# Meliadine Extension – Meliadine Mine

DFO Technical Comment Responses and Commitment Follow-up

**Fisheries and Oceans Canada**

Agnico Eagle Mines Limited – Meliadine Division

Figure 3-1: Meliadine Extension Footprint (green polygons) and Affected Watersheds

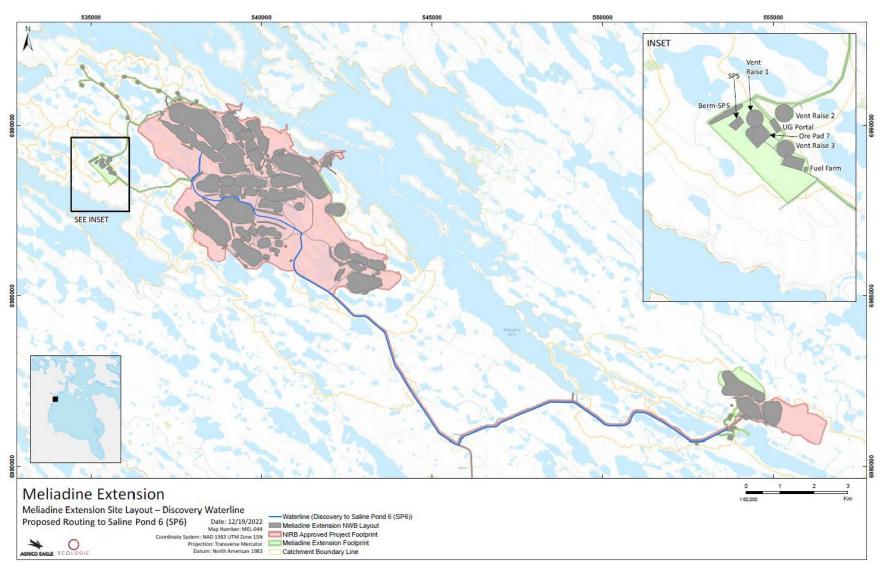
This section provides follow-up information to resolve Technical Comments DFO-TRC-03, DFO-TRC-04, DFO-TRC-05, DFO-TRC-06, DFO-TRC-07, and DFO-TRC-08. This section summarizes the information for the 2014 FEIS in comparison to the Meliadine Extension FEIS Addendum for area of the watershed with a direct mine infrastructure footprint, effects to flows, and effects to fish and fish habitat. More detail is provided for sub-watershed A and B as there will be larger mine footprints within these sub-watersheds. Table 3-1 summarizes the calculated total watershed area to be 7,231.4 ha. The NIRB approved footprint was anticipate to affect about 2,201 ha (30%) of the total watershed area; whereas the Meliadine Extension will be approximately 44.7 ha smaller. Figure 3-1 shows the Meliadine Extension footprint and the affected watersheds.
